UNITED STATES PATENT AND TRADEMARK OFFICE

APPLICATION NO.	FILING DATE	FIRST NAMED INVENTOR	ATTORNEY DOCKET NO.	CONFIRMATION NO.
10/737,311	12/16/2003	Dennis Kelly	1-24296	5955

Office Action Summary	Application No. 10/737,311	Applicant(s) KELLY ET AL.	
	Examiner Melody M. Burch	Art Unit 3683

DETAILED ACTION

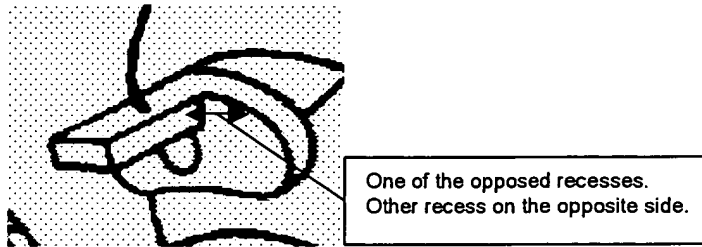
Re: claims 23, 31, 39, 40, and 45. Anger et al. show in figure 3 a method for producing a vehicle brake assembly comprising providing a backing plate 12 having a centrally located first aperture formed therein shown in the area surrounding element number 24, the backing plate 12 or at least portion of backing plate 12 shown in area of element 24 (labeled element 20 in figure 2) adapted to support a drum brake shoe assembly 10 of a drum in hat parking and emergency brake, and a one piece integral stamp formed drum in hat adapter 16 shown in figure 3 and disclosed in col. 3 line 5 having an abutment member 30 and a pair of ears one of which is shown in the area of the lead line of number 16 formed integral therewith, the one piece integral stamp formed drum in hat adapter having a centrally located second aperture as shown and a plurality of smaller mounting apertures shown to the left of the lead line of number 16 and to the right of the lead line of number 30 and disclosed in col. 3 line 6 formed therein about the centrally located first aperture thereof, the abutment member

protruding from the one piece stamp formed drum in hat adapter and including an appropriately shaped profile for directly receiving an associated end of a pair of brake shoes of the drum brake shoe assembly as disclosed in col. 2 lines 64-67.

Re: claims 30 and 44. Opposed recesses are shown below in the modified version of a portion of Anger et al. figure 3.

Re: claim 38. Opposed recesses are shown in the modified version of a portion of Anger et al. figure 3 on pg. 4 of the Office action.
